PRODUCT/PROCESS CHANGE NOTICE (PCN)

PCN #: A1301-08 DATE: February 5, 2013 Product Affected: 3.0mm x 3.0mm VFQFPN-20 4.0mm x 4.0mm VFQFPN-24 4.0mm x 4.0mm VFQFPN-28 (Refer to Attachment 2) Date Effective: May 5, 2013	MEANS OF DISTINGUISHING CHANGED DEVICES: <input type="checkbox"/> Product Mark <input type="checkbox"/> Back Mark <input type="checkbox"/> Date Code Assembly lot marked on the device provides traceability to the material used <input checked="" type="checkbox"/> Other
--	---

PCN Type: Assembly Process and Material Change

Figure 1: Illustration of Interposer Inserted between top die and bottom die (Top View)

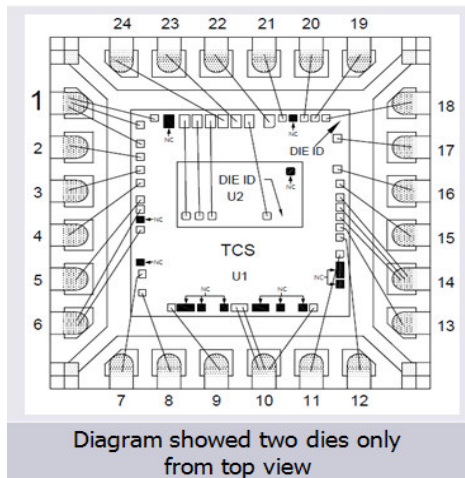
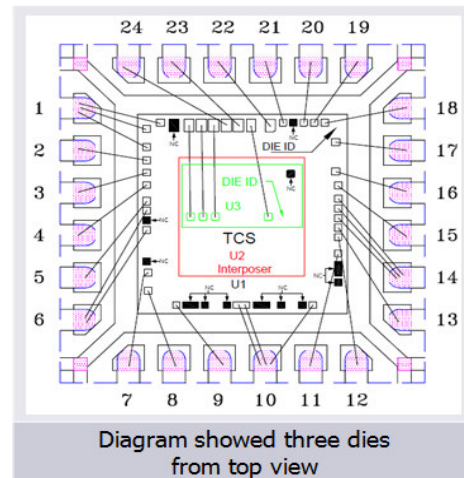
This notification is to advise our customers that IDT has successfully completed the qualification of stack die assembly with interposer. An interposer will be added in between the top die and the bottom die to improve assembly yield.

The die attach material for the top die will change to NEX-130SB-25 and for the bottom die to 8200T.

Description	Changes	
	From	To
Package Technology	Without Interposer	With Interposer (inserted between top and bottom die)
Die Attach (Top Die)	NEX130CT	NEX-130SB-25
Die Attach (Bottom Die)	8600	8200T

Figure 2: Illustration of Interposer Inserted between top die and bottom die (Side View)

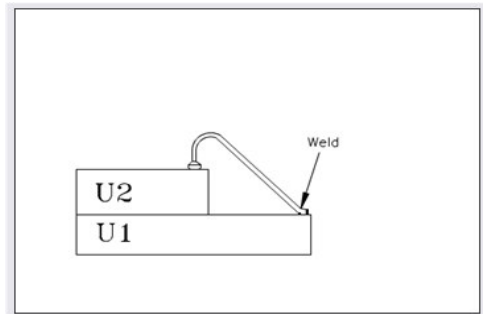
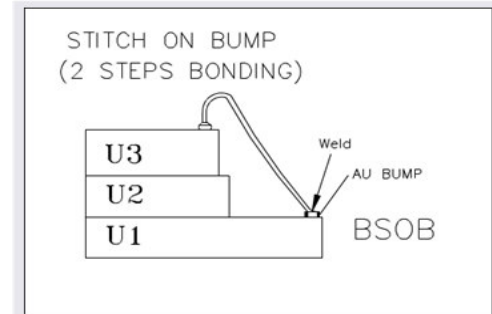
Diagram showed two stack dies only from side view

Diagram showed three stack dies from side view
